**Addendum to Remedial Action Options Report (RAOR) and Pre-Design Sampling Work Plan - Connell Aluminum Properties, LLC  
Former Koppers Tar Plant and Wabash Alloys Site  
9100 S. 5<sup>th</sup> Avenue, Oak Creek, WI 53154  
BRRTS# 02-41-553761, FID#241379050  
Connell VPLE BRRTS #:06-41-560068**

March 13, 2020

**City of Oak Creek Utility Corridor Lot 1  
9170 South 5<sup>th</sup> Avenue, Oak Creek, WI 53154  
BRRTS#: 02-41-561425, FID #:341074470  
VPLE BRRTS#: 06-41-561426**

This Addendum letter addresses the WDNR's comment letter dated October 25, 2017 provided to Connell regarding *Review of Site Investigation and Remedial Action Options Reports, Former Koppers Tar Plant and Wabash Alloys Facility*. Reference is made in this letter report and/or on attached figures to the remedial actions proposed to be completed by Beazer East, Inc. including DNAPL tar removal, and barriers for PAH-contaminated soil using soil cover or potentially mobile tar capping using geomembrane.

**FIGURE 1**  
FIGURE 9 (REV. RAOR REPORT)

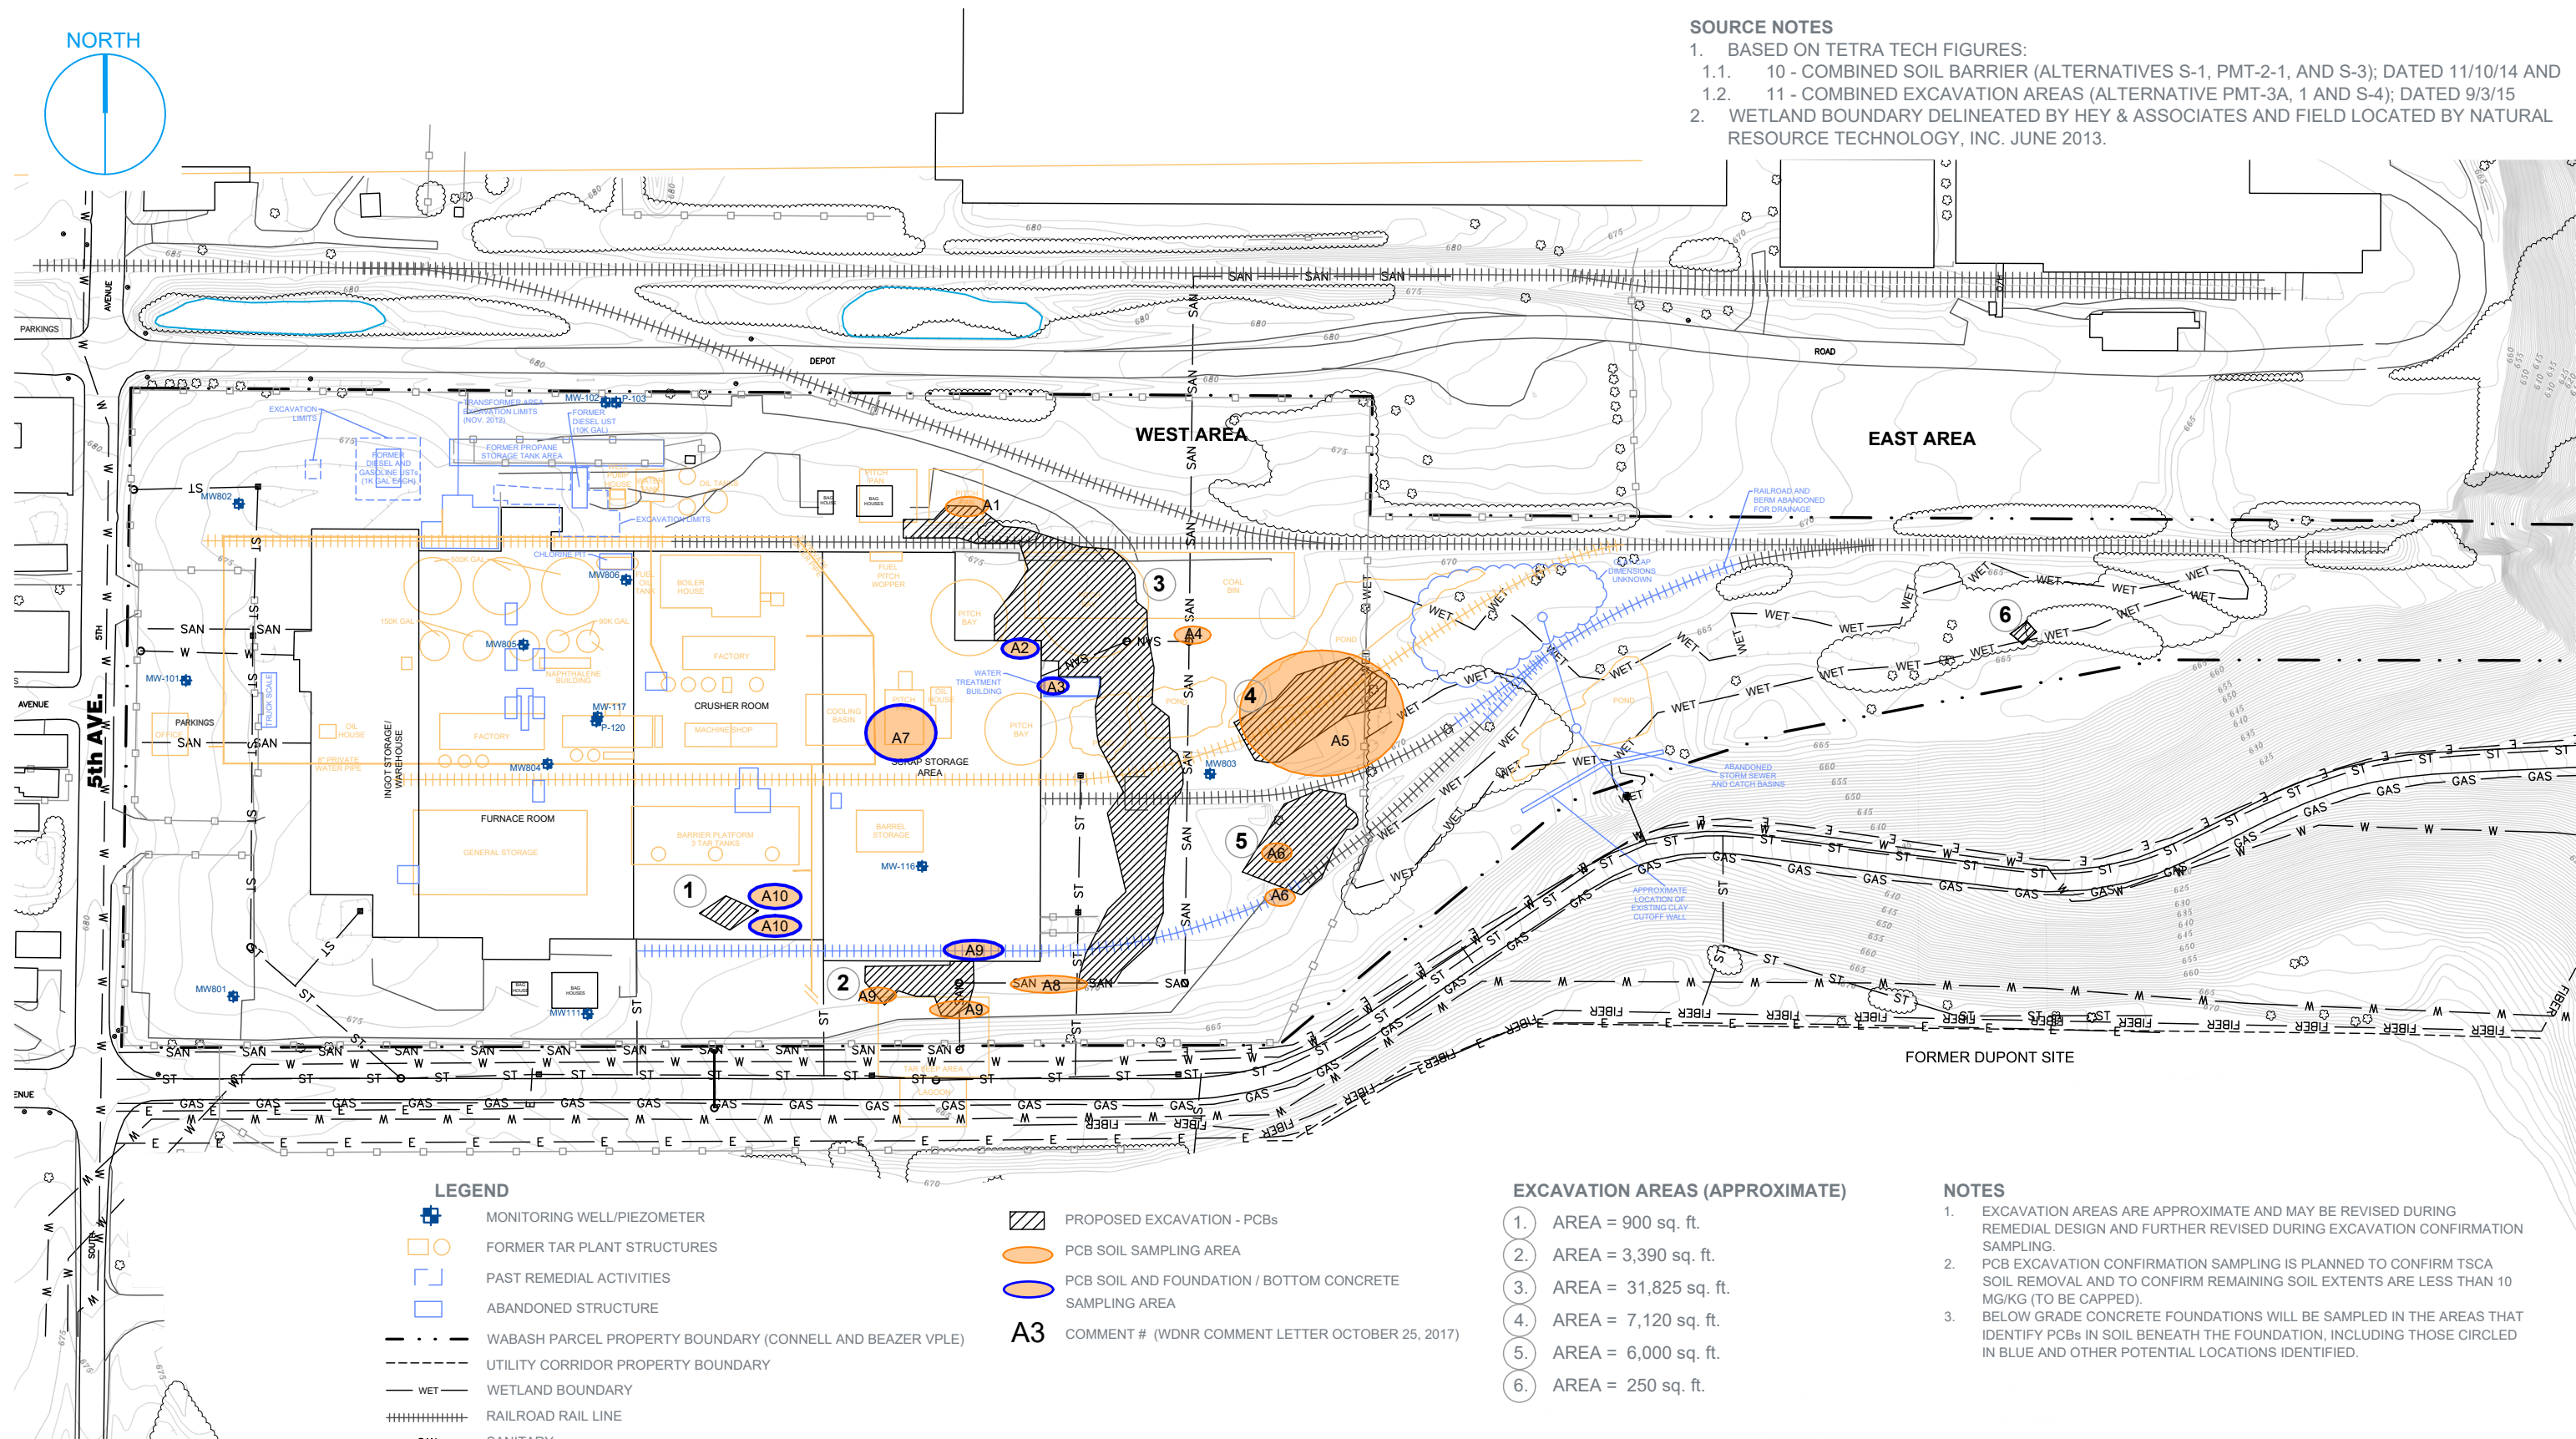
- Figure 1 – Revised RAOR Figure 9 – PCB Soil Excavation and Disposal (Alternative S-4) for purposes of showing all 6 planned excavation areas (Western Areas 1 through 5 and Eastern Area 6) and showing all 10 locations by comment number (A1 through A10) that WDNR identified as additional PCB sampling locations. Note 1 was revised and Notes 2 and 3 were added to include notes about the planned excavation confirmation sampling and sampling of the below grade concrete foundations where PCBs are identified in soil.

**FIGURE 2**  
**FIGURE C40 (REV. SI REPORT)**

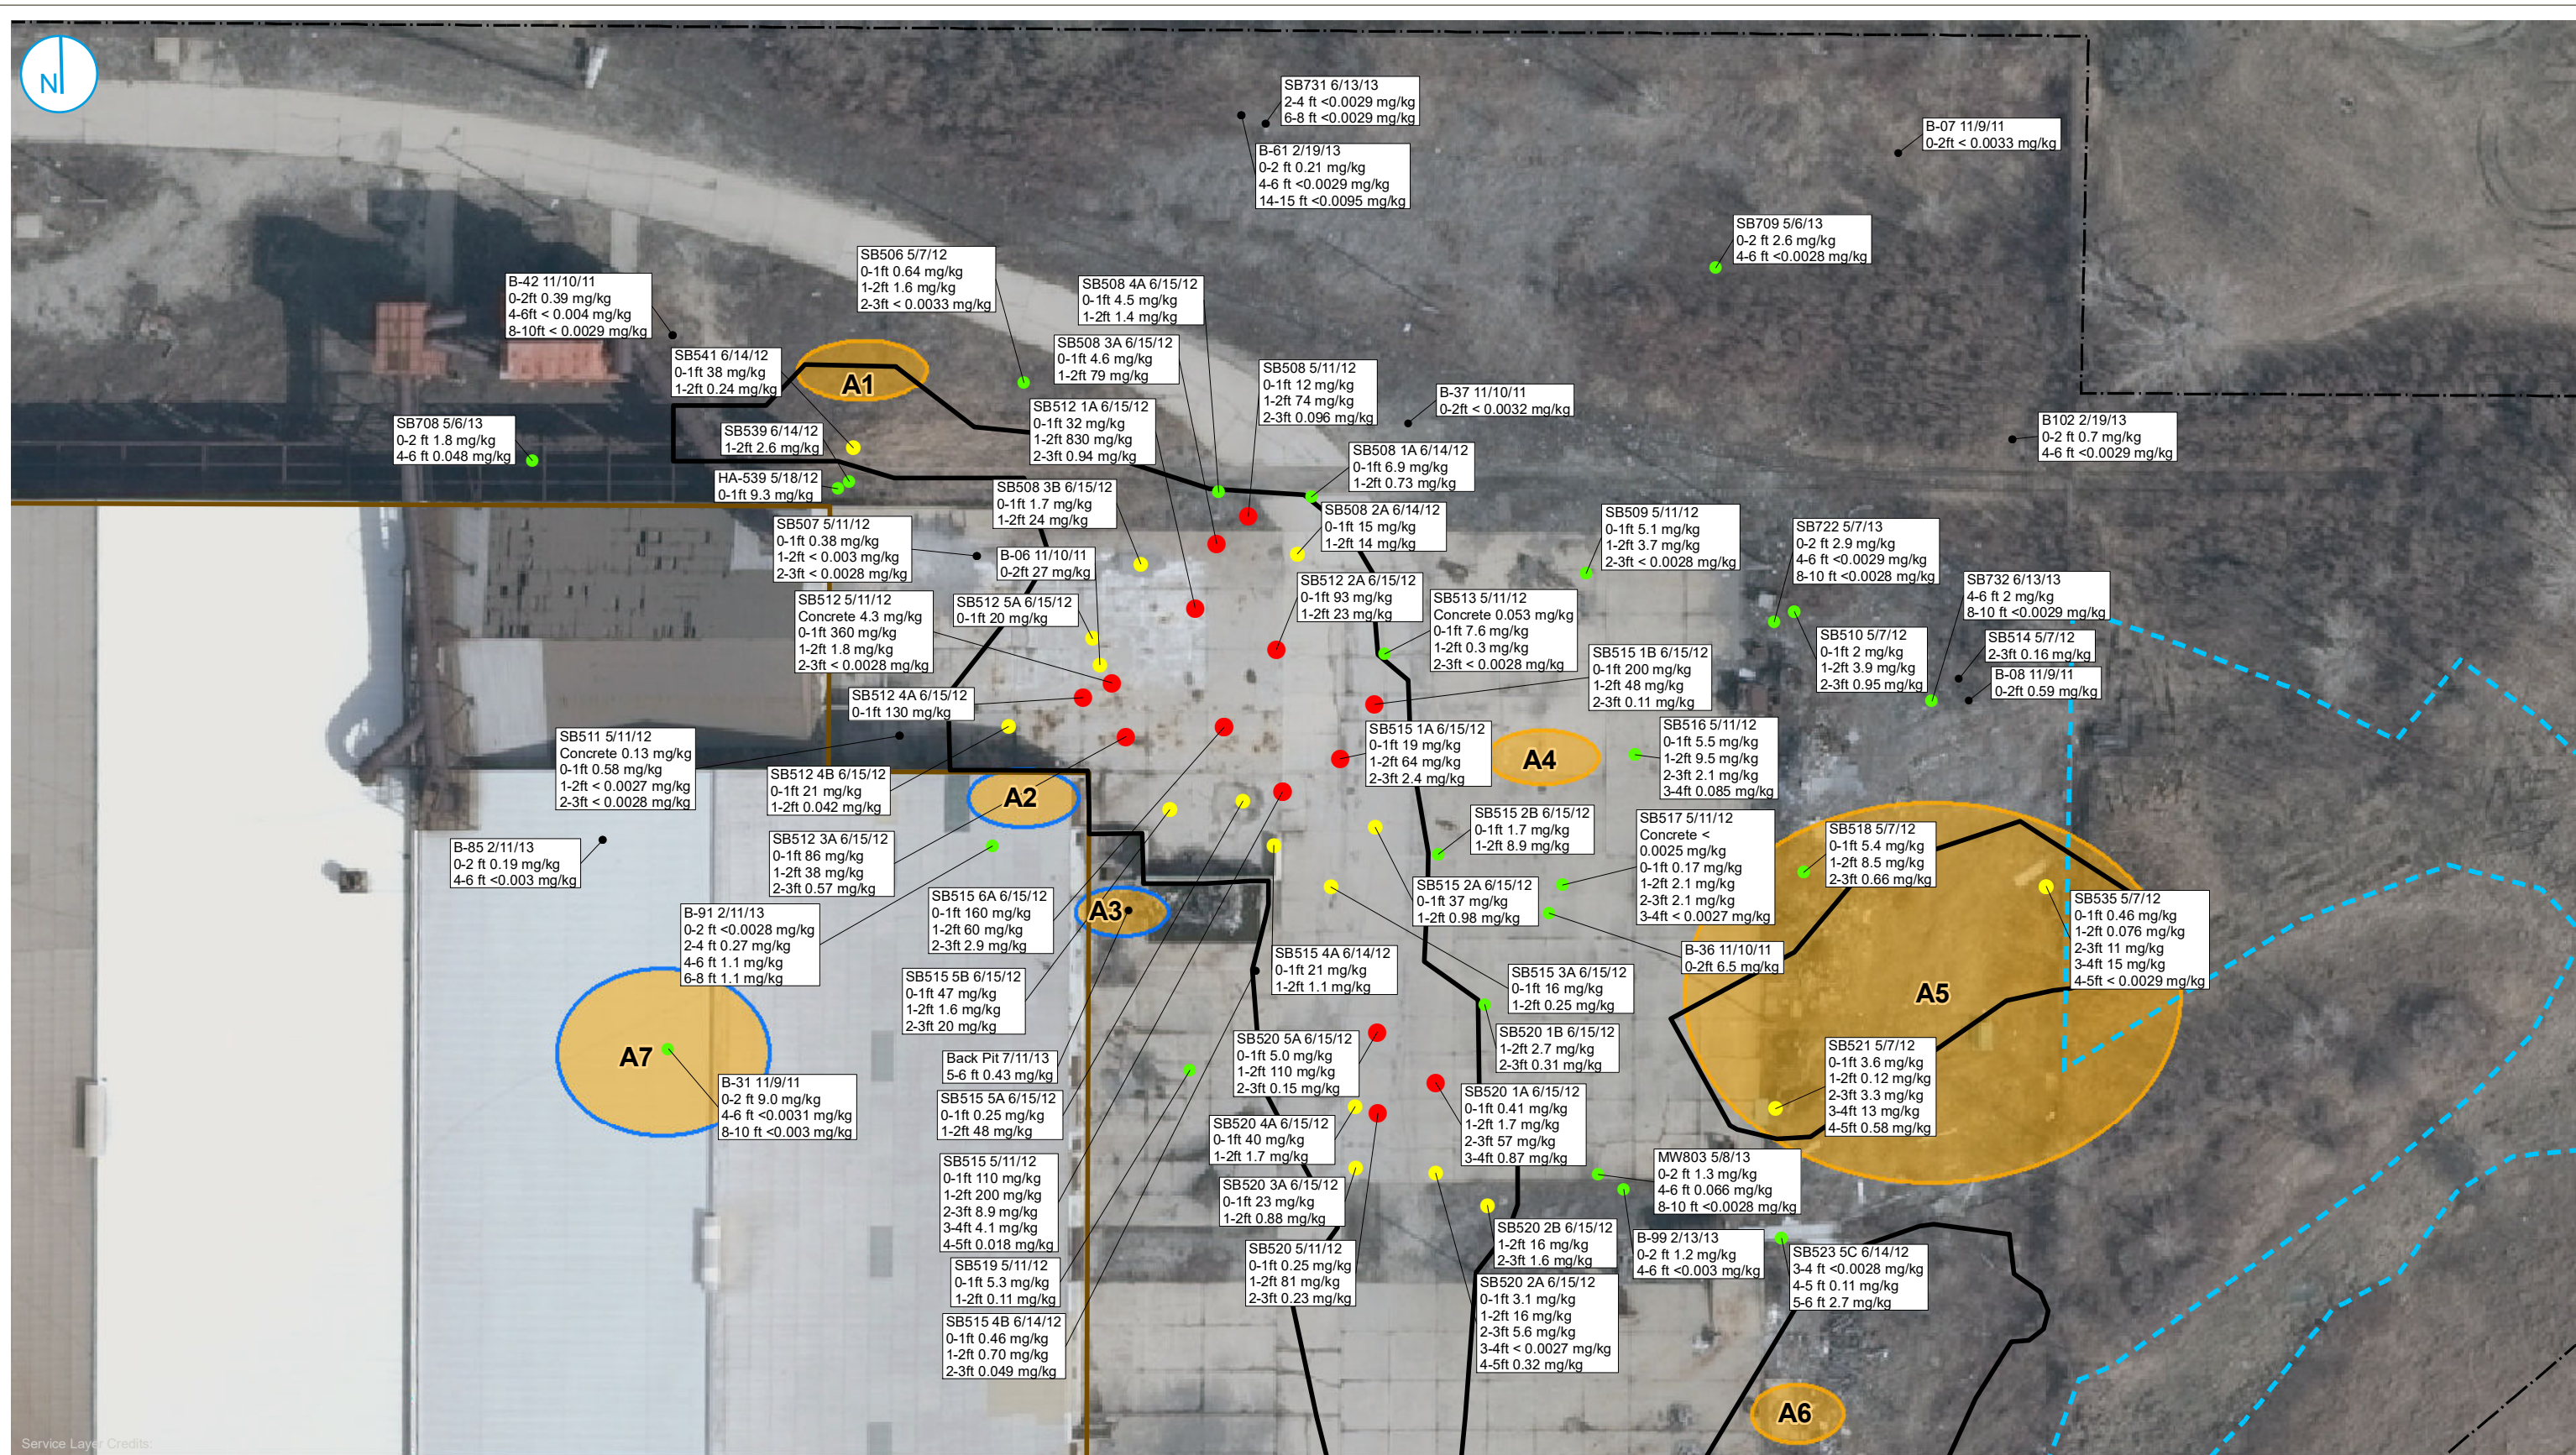
- Figure 2 – Revised Figure C40 SI Report - PCB Soil Data – North Yard TSCA Area for purposes of showing more specifically the additional PCB sampling locations related to comments A1 through A5, and A7.
